High Rise Sign

LOT 1, Block A
Quiktrip 8th Addition
Wichita, Kansas
Elevation Exhibit

Wichita-Sedgwick County Metropolitan Area Planning Department

RE: **BZA2004-00036: Sign Code Adjustment to increase the maximum allowed height of a sign to 20 feet above the height of the highway railing at a point perpendicular to the sign.**

P–015

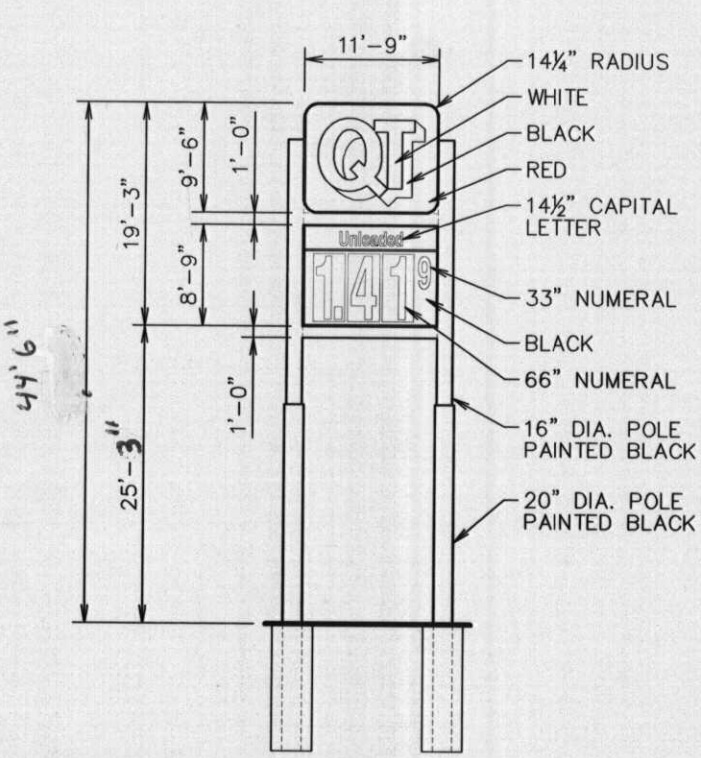
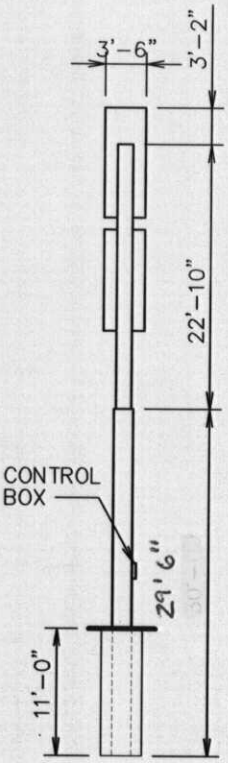
1) There shall be only one sign permitted along the subject property's Kellogg frontage. Said sign shall be limited to a maximum height of 44.5 feet and a maximum area of 228 square feet. Said sign shall generally conform to the location and design of the approved site plan and elevation drawing.
